NUMBER: SB-213-027
DATE: 2/7/03
MODEL: All Engines
with J-Tech™

(Also applies to Mack Trucks Australia)
(Supersedes bulletin SB-213-027 dated 10/29/02)

VALVE YOKE GUIDE PIN, ROTATOR AND SLAVE PISTON SPRING BREAKAGE — ENGINES EQUIPPED WITH J-TECH™ ENGINE BRAKE

Figure 1 — J-Tech™ Engine Brake Reset Screw, Slave Piston Spring and Actuating Pin Adjusting Screw

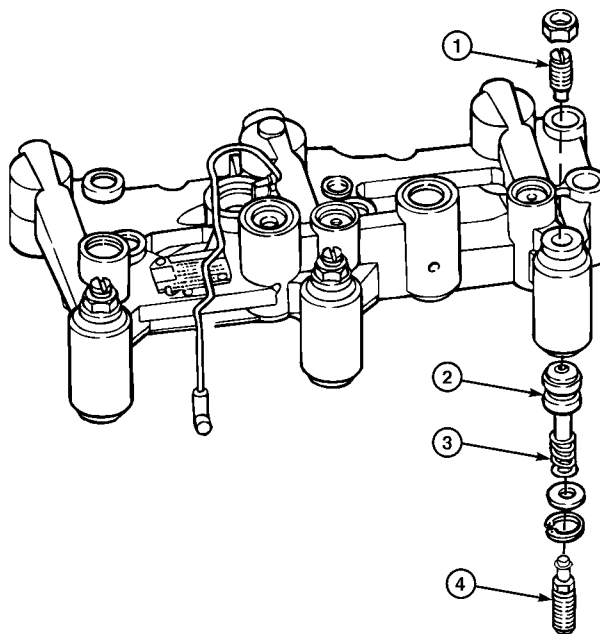
When investigating causes of valve yoke guide pin breakage, the J-Tech™ engine brake reset screws and slave piston springs must be inspected and updated to the current components if they have not already been updated. The current reset screws can be identified by the part number stamped next to the screwdriver slot. If part No. 032053A is stamped on the reset screws, the brake unit in most cases will contain the current slave piston springs. Engine brake units having the updated reset screws and slave piston springs can also be identified by the part number stamped on the engine brake identification plates. Engine brake units having MACK part Nos. 75GB59B or 757GB59C contain the updated components.

REV For engine brakes not already updated with the current reset screws and slave piston springs, a service kit (part No. 215SB321), which includes six improved reset screws (part No. 4559-32053), six slave piston springs (part No. 4559-30860) and six actuating pin adjusting screws (part No. 421GC41CM), is now available through the MACK Parts System. The single slave piston springs replace the previously used dual spring arrangement.

Take care not to mix the old reset screws with the new screws. The new screws are approximately 0.330" (8.4 mm) longer than the old screws. The new screws can also be identified by the part number (032053A) stamped on the top of the screw next to the screw slot.

* Reset screws, slave piston springs and actuating pin adjusting screws (items 1, 3 and 4 in the illustration above) are all included in the J-Tech™ Reset Screw/Slave Piston Spring service kit (part No. 215SB321)

If the engine is equipped with external oil supply lines to the engine brake units and the engine brake has not been previously updated as described in this bulletin, service kit part No. 215SB321 must be installed to prevent valve yoke guide pin breakage.

Figure 2 — Engine Brake Unit Identification Plate

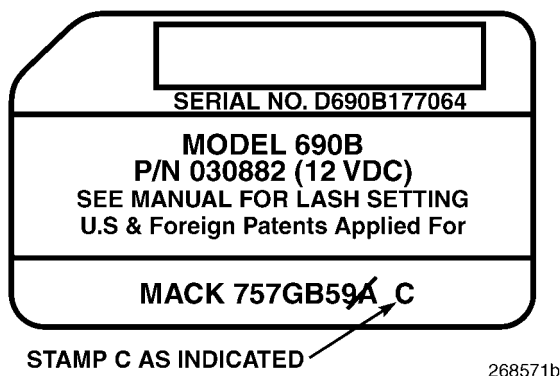
17. To identify that the engine brake units have been updated with the new slave piston springs, stamp a letter "C" to the right of the engine brake housing part number (757GB59) located on the housing identification plate. If the part number ends with the letter "A" (757GB59A), cross out the "A" and stamp a "C."

Figure 3 — Actuating Pin Adjusting Screw Assembly

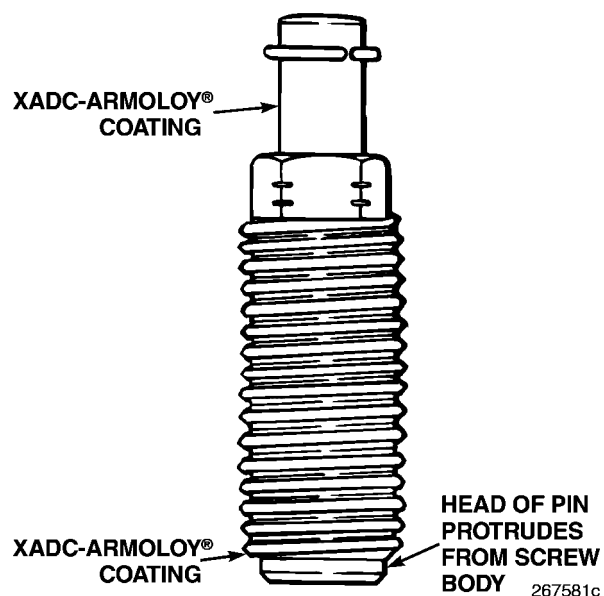
The head of the actuating pin should protrude from the adjusting screw body as shown in the following illustration.

Effective approximately mid-August 2002, a new engine brake actuating pin adjusting screw assembly (part No. 421GC41CM) was implemented into engine production. The bottom pin-seat surface of this screw body and the entire surface of the floating pin are coated with an XADC-Armoloy® coating. The XADC-Armoloy® coating features the inclusion of synthetic nano-diamond with the thin dense chromium, and provides significant improvements in hardness and wear resistance. Actuating pin adjusting screws having the XADC-Armoloy® coating can be identified by the dull aluminum color of the screw body pin seat surface, and on the lower side of the first thread. The rest of the screw body is the same black color as the previous screws. Another means of identifying a 421GC41CM screw is by looking at the floating pin. The pin is fully coated with Armoloy coating on these screws, whereas the pin on the previous part number screws was not.

Figure 4 — Worn Actuating Pin Adjusting Screw

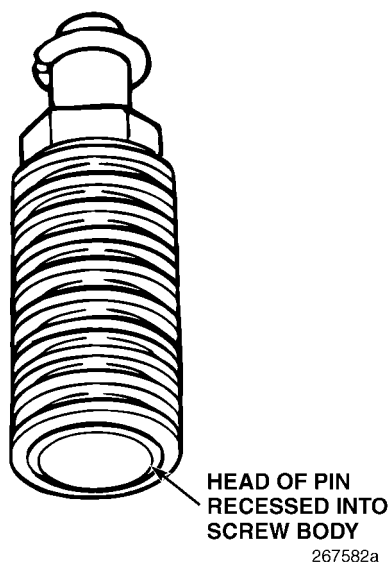
With the previous actuating pin adjusting screw assemblies (part Nos. 421GC41M or 421GC41AM), wear of the screw body can result in the pin recessing into the screw until flush with the screw body as shown in the illustration below.

In severe cases, the end of the adjusting screw threads may be worn or broken due to contact with the valve tip.

Figure 5 — Measuring Actuating Pin Adjusting Screw Assembly

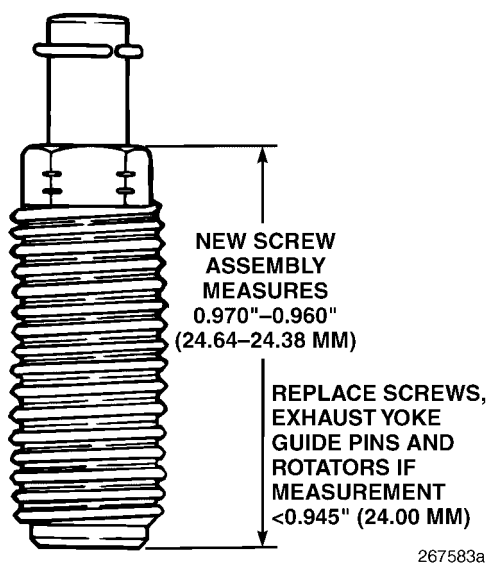
The length of the adjusting screw assembly, from the face of the actuating pin to the top of the screw body, should be 0.970"–0.960" (24.64–24.38 mm). If any one of the adjusting screw assemblies measures less than 0.960", all six of the screws should be replaced with six XADC-Armoloy® screws (part No. 421GC41CM).
